**Cascade Charter Township Planning Commission**

**Monday, December 05, 2016**

TO: Cascade Charter Township Planning Commission  
FROM: Steve Peterson, Community Development Director  
REPORT DATE: November 28, 2016  
MEETING DATE: December 5, 2016  
CASE: #16-3329/ Spees PUD amendment

Re: Taco Bell and Freddy's  
Site Plan Review

**C2.0**

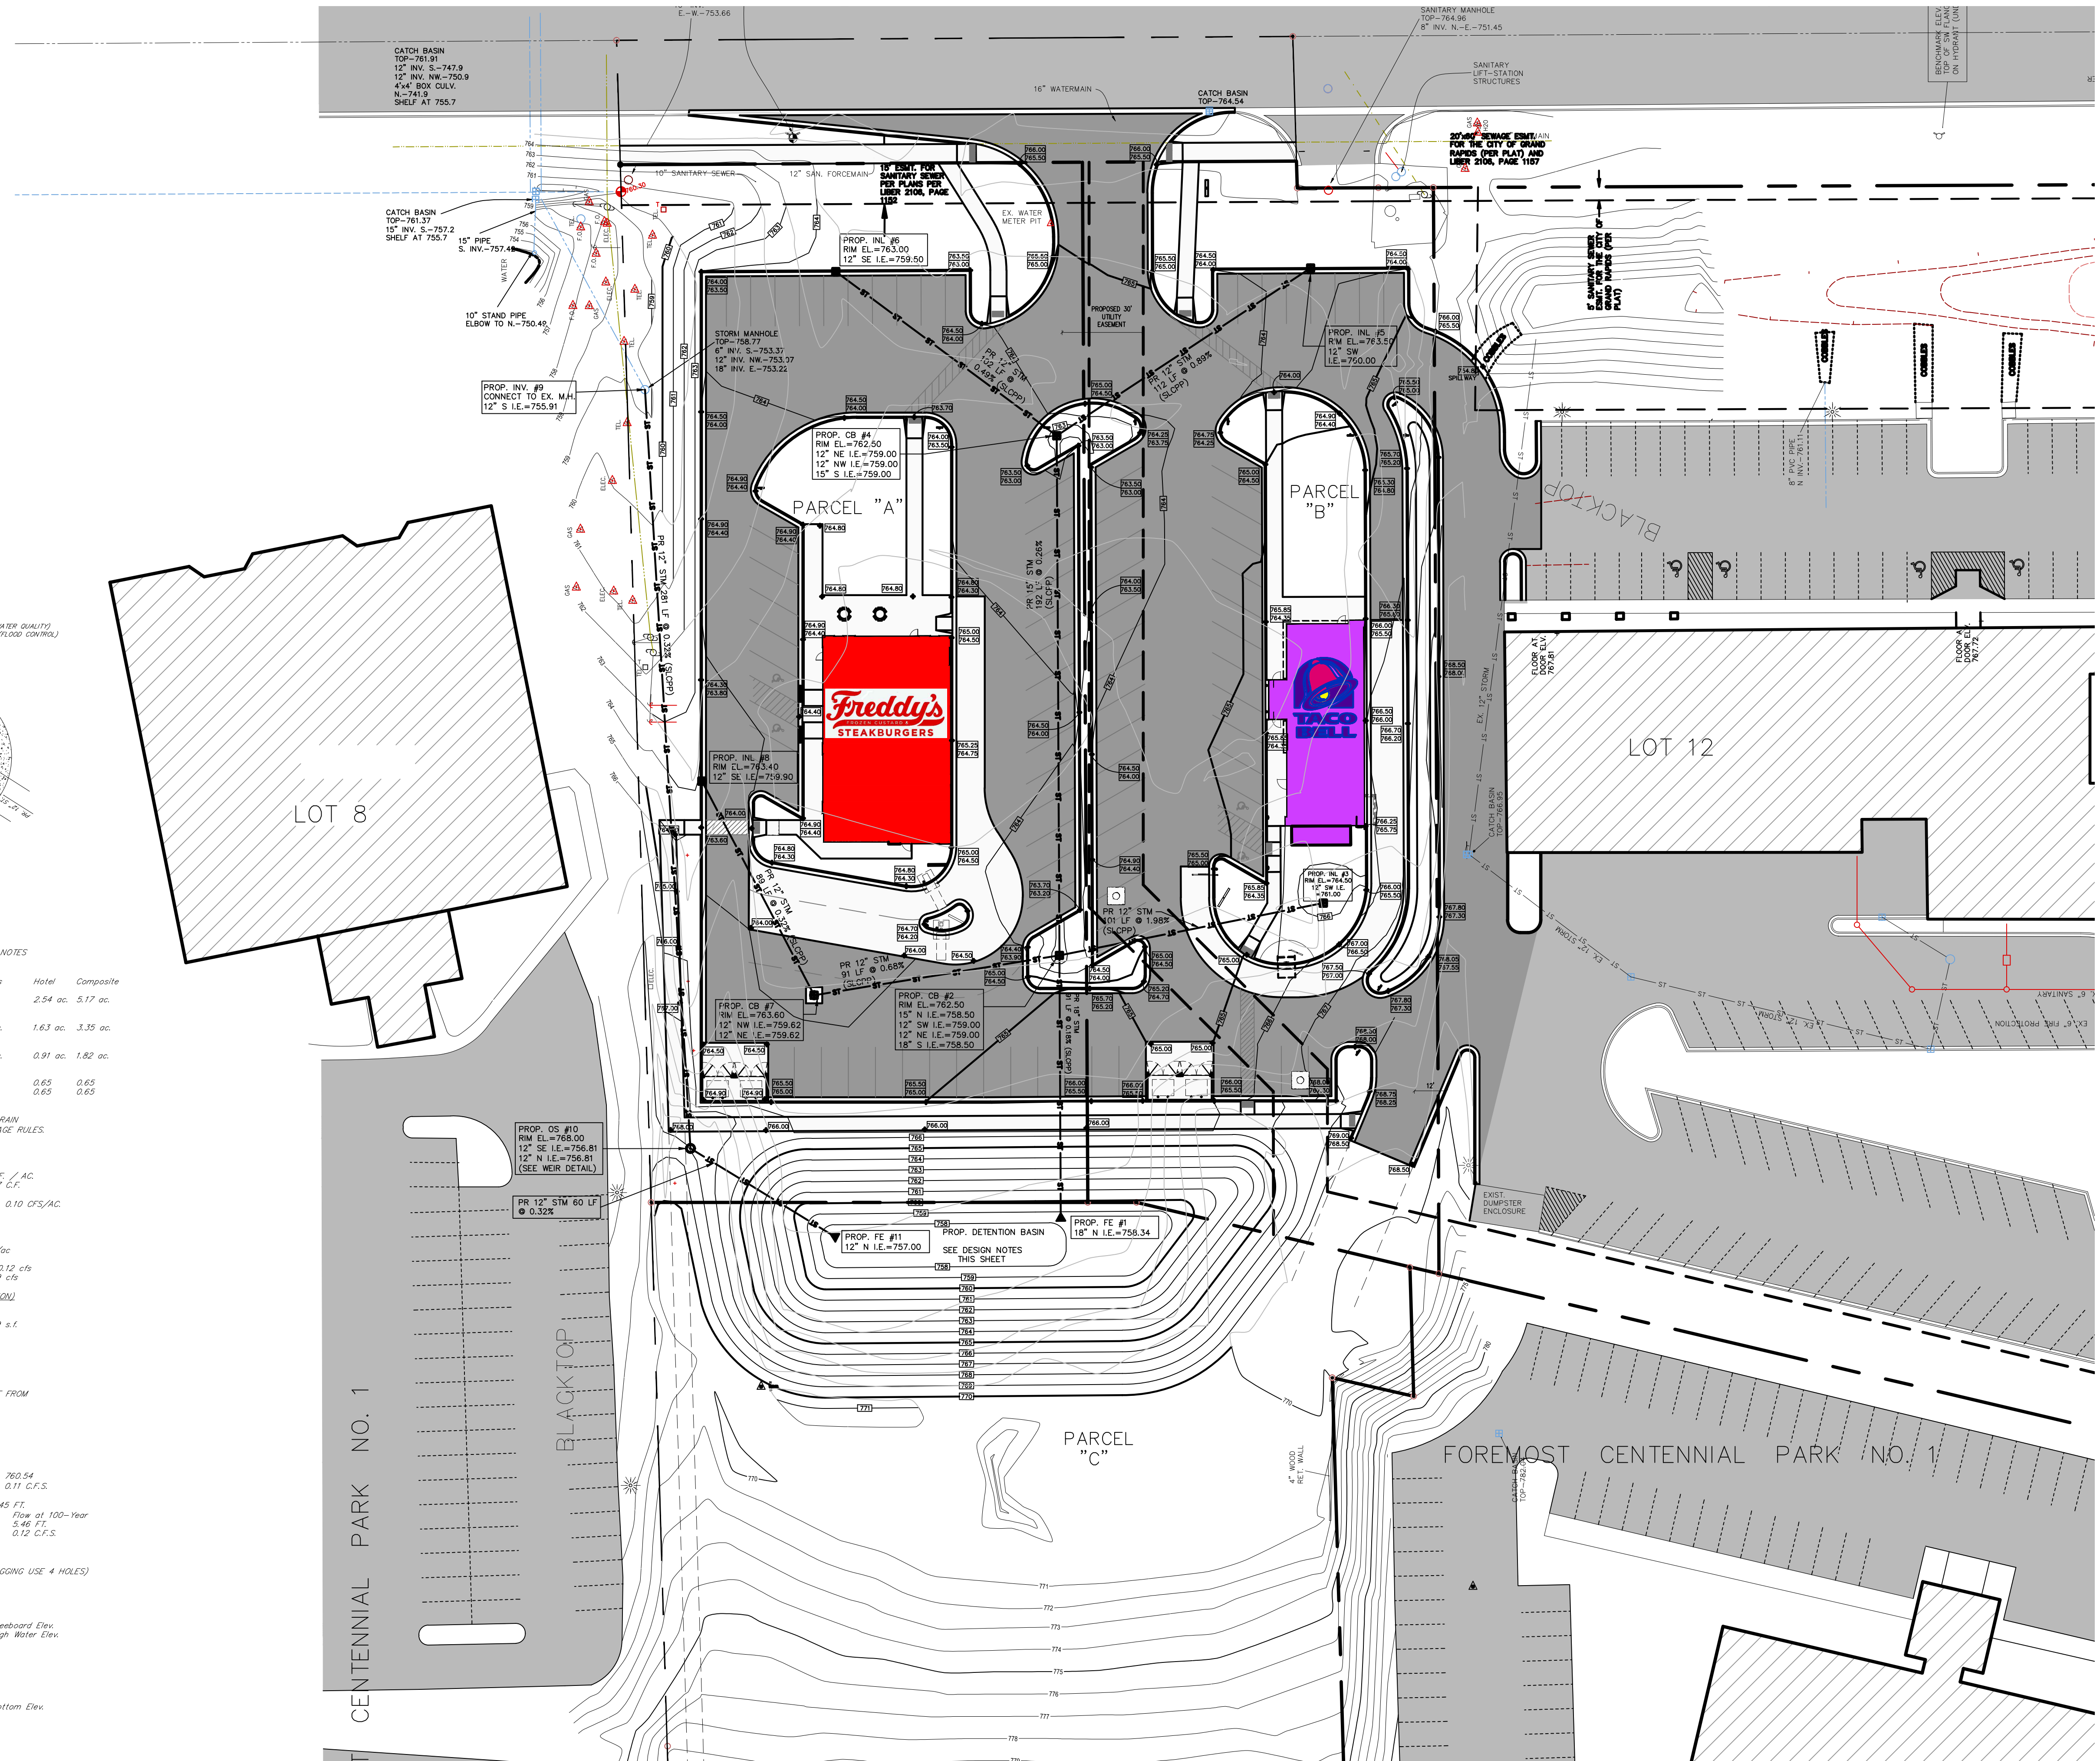
The south half of the site is not being developed at this time. The applicant has stated it is unknown what will ultimately be developed there. The proposed detention basin was sized for full buildout of the site assuming a typical land use for the south half of the site. A runoff coefficient of 0.65 was assumed for full buildout of the site. At the time the south half of the site is developed, the stormwater calculations and detention basin will need to be reviewed for SWO compliance and revised accordingly. The proposed design meets the requirements of the SWO.

The applicant has submitted drawings, calculations, and additional documentation as required in the SWO Section 2.03, Drainage Plan. Please refer to the included checklist for items and comments on each item. Please note a maintenance agreement is required before construction begins. The agreement should be submitted to the Township for review. The maintenance agreement and plan should include at a minimum, cleaning of catch basin sumps, sediment and debris removal from the detention basin, and landscape maintenance of the detention basin to maintain the design volume and ensure the system is operating as it was designed.

- NR (11) Maintenance agreement, in form and substance acceptable to the Township, for ensuring maintenance of any privately owned storm water runoff facilities. The maintenance agreement shall include the developer's written commitment to provide routine, emergency, and long-term maintenance of the facilities and, in the event that the facilities are not maintained in accordance with the approved drainage plan, the agreement shall authorize the Township to maintain any on-site storm water runoff facility as reasonably necessary, at the developer's expense  
*Maintenance agreement was not provided and is required.*

The proposed stormwater design meets the Township SWO requirements for new developments. The applicant will need to apply for and obtain a number of permits (SESC, water and sanitary sewer from the City, KCRC for the new driveway) prior to beginning construction. We recommend approval of the site plan from an engineering standpoint.

**A4.0**

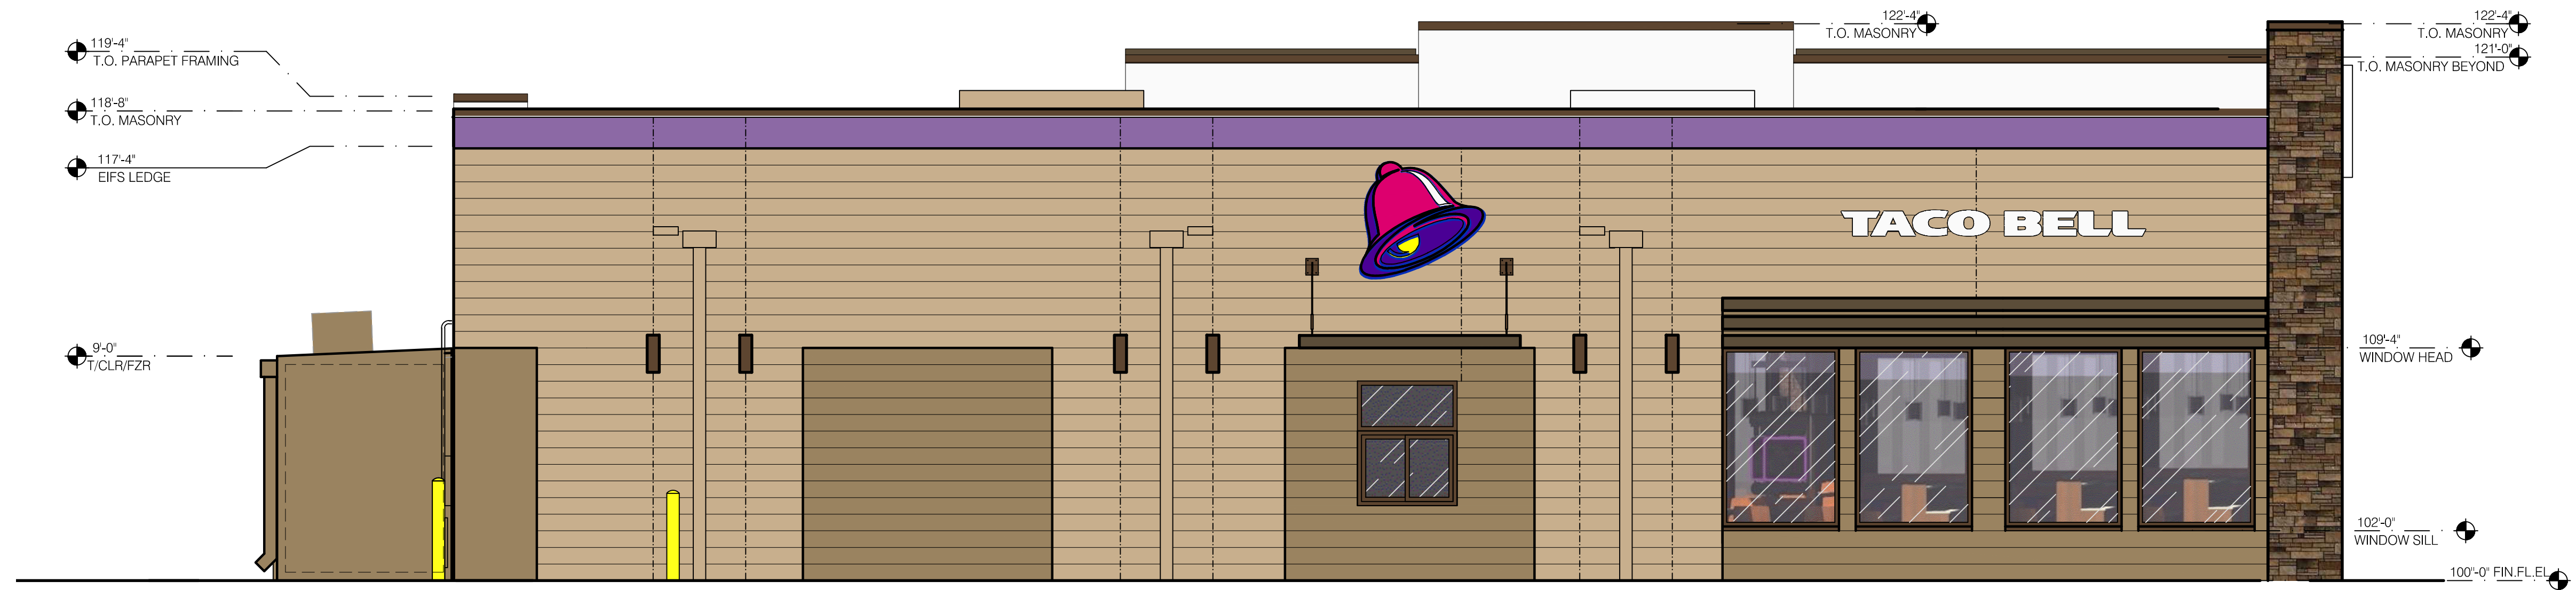
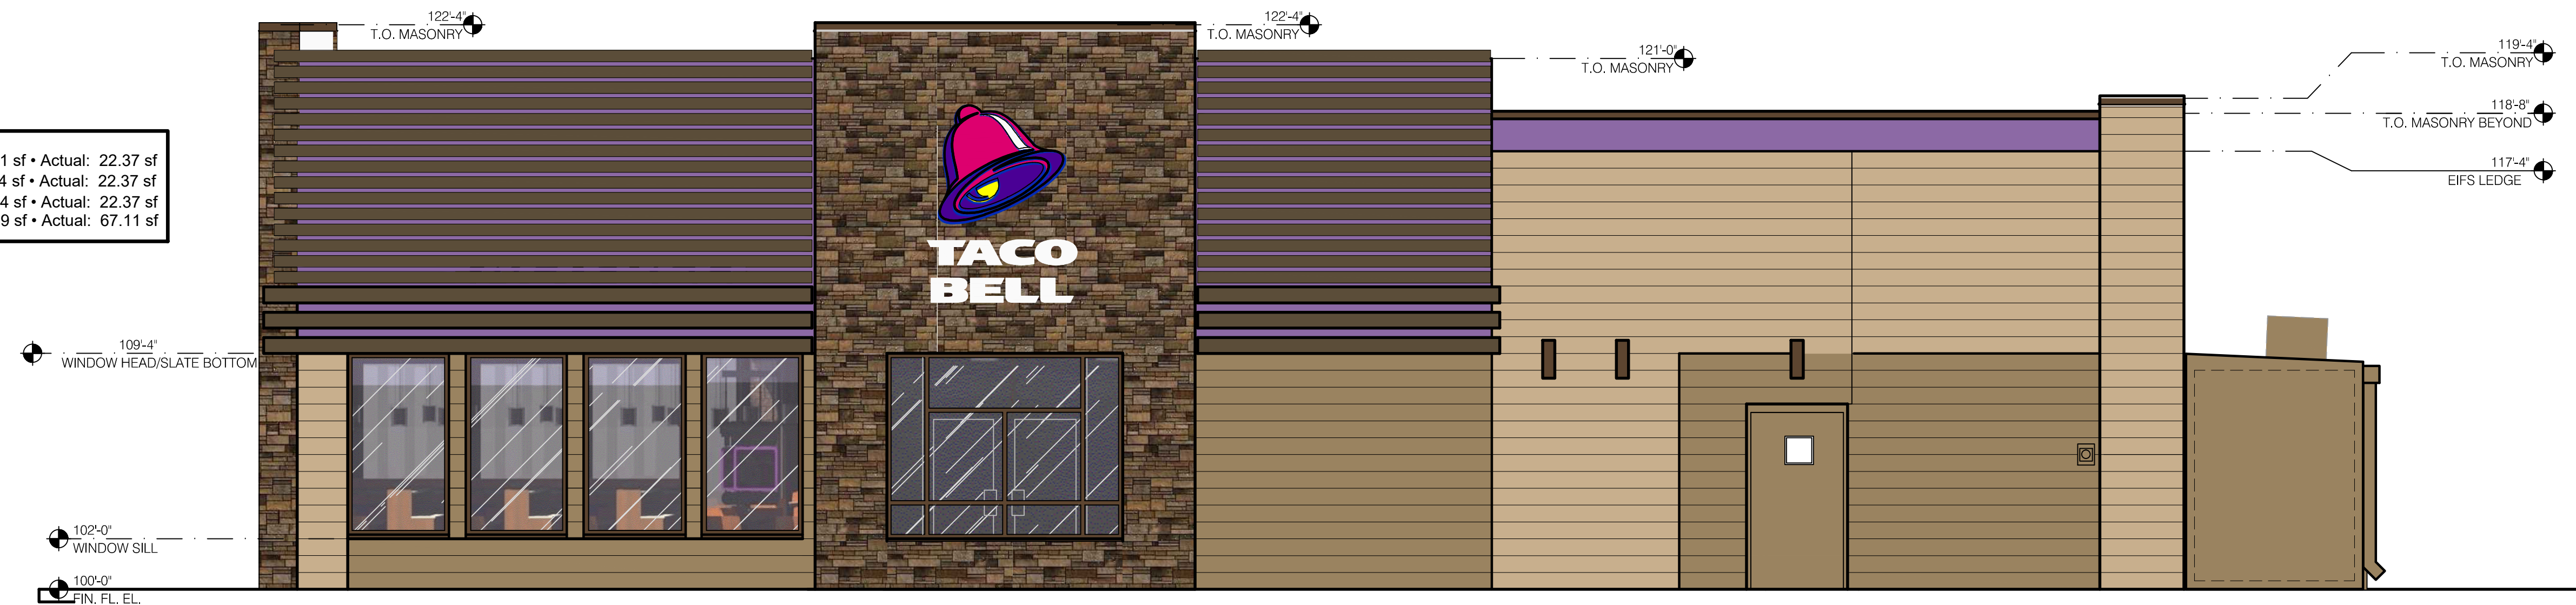
- M. Signage has been developed to show slightly additional wall signage than what we allow. Freddy's proposes 100 sq ft of wall signage and taco bell proposes 108 sq ft. They are both allowed 100 sq ft in total. They are also showing a pylon sign out front to accommodate the entire site. This sign is proposed at 135 sq ft. with 280 feet of frontage they would be allowed a 56 sq ft pylon sign. I think the wall signage is fine but I do not see a reason to allow triple the amount of a pylon sign. 125 sq ft is the max for anyone so even if we were to allow for a bigger pylon it could not be more than 125 sq ft. I would suggest allowing up to 70 sq ft for a pylon and reducing the height to no more than 15
